RP7 - NIE Networks Price Control 2025-2031

Draft Determination Annex P
Assessment of Network Investment Direct
Allowances
November 2023

Figure 3.1: Outturn cumulative and annual average unit cost from 2013 to 2023

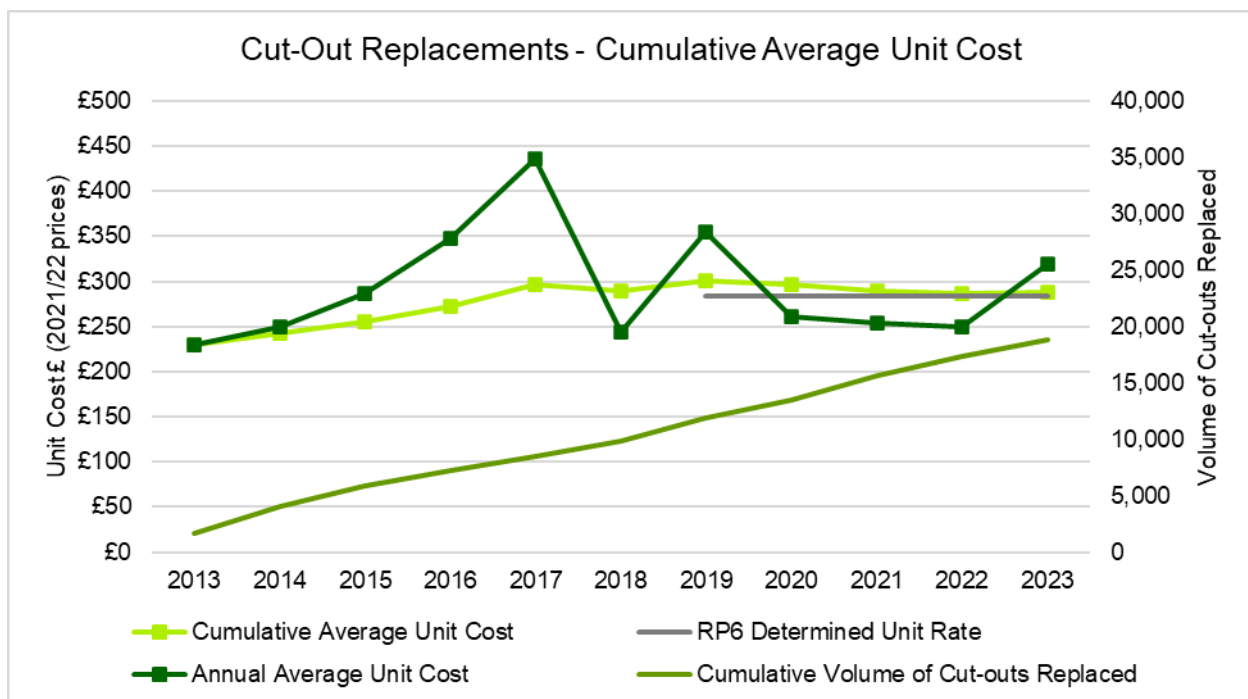
The existing cut-outs replacement programme is now well established, with over 10 years of outturn data available, which will be reflective of a wide variety cut-out replacements, unless there has been a conscious deferral of more complex works. As the figure below shows, the cumulative average unit cost has stabilised within a +/-5% range since 2016, on a cumulative total of 18,866 cut-out replacements, whilst there has been greater variation in the annual average unit cost, which may be representative of the variation of tasks encountered within that year.

3.110 For RP6 we set the allowed unit rate at £282.73, which was the RP5 outturn to that stage. NIE Networks argued then that it had undertaken a 98:2 simple versus complex split in RP5 and that determining based on the RP5 outturn wasn't suitable for its forecast 90:10 split in RP6. The RP6 outturn to March 2023 is £288.42, 1.7% above the determined allowance. We believe this

Figure 3.2: Outturn & forecast delivery volumes

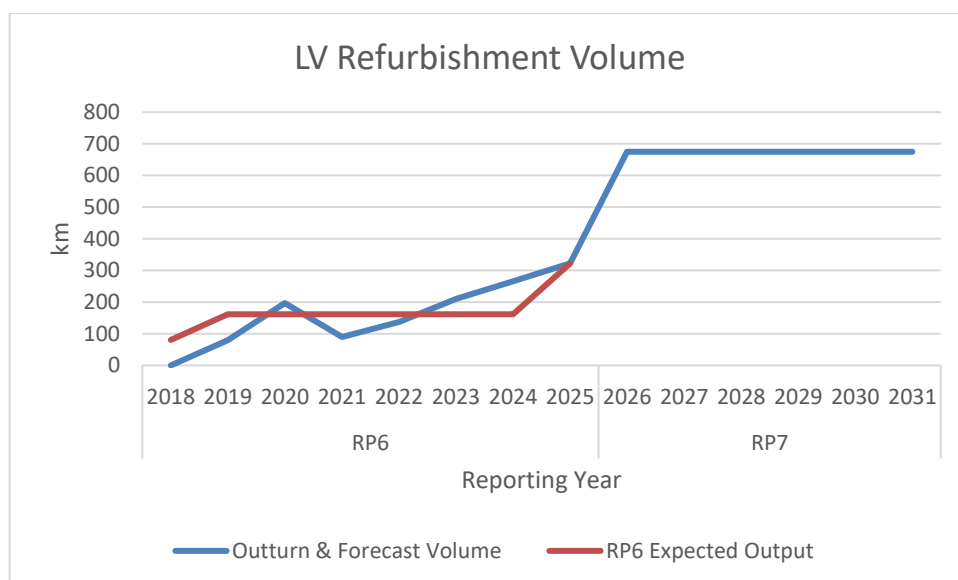
3.167 NIE Networks has proposed an ambitious plan to increase delivery of LV overhead line refurbishment volume during RP7. The graph shown in figure 3.2 shows output (outturn & forecast) during RP6 and the subsequent increase during RP7.

3.168 Based on historic outturn volumes being below those expected, we have concerns that NIE Networks will be unable to increase output to its proposed RP7 volumes. However, given the upturn in output since 2021 we are willing

to allow the RP7 proposed volumes (less the deduction in 3.166 above) in the knowledge that the deferral mechanism will deal with any under-delivery in RP7.

Figure 3.3: Outturn Unit Cost

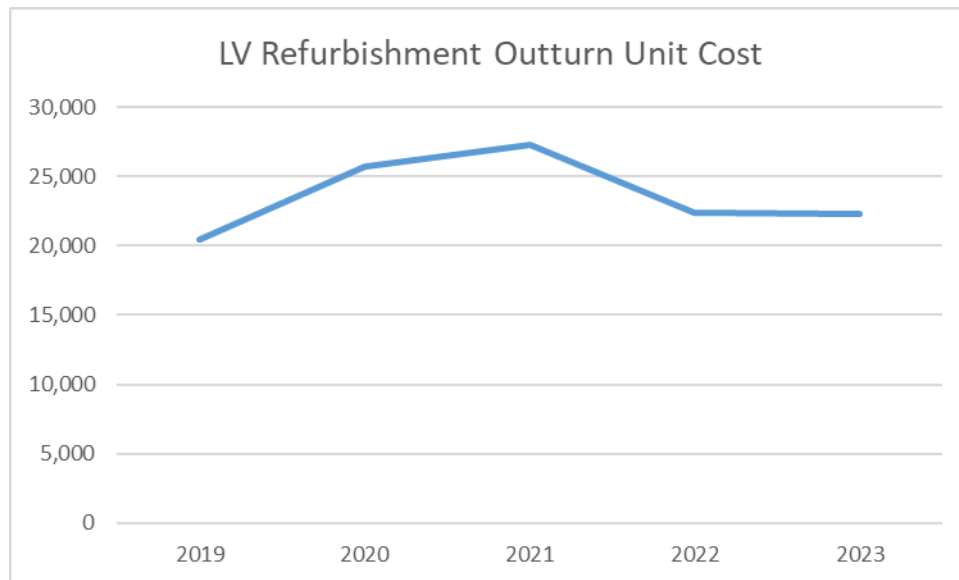
3.169 The historic outturn unit cost/km is shown in figure 3.3 below.

3.170 We are aware of increased contractor costs negotiated by NIE Networks in the second half of 2022. However, due to reporting lag we have seen no evidence of the increased costs yet.
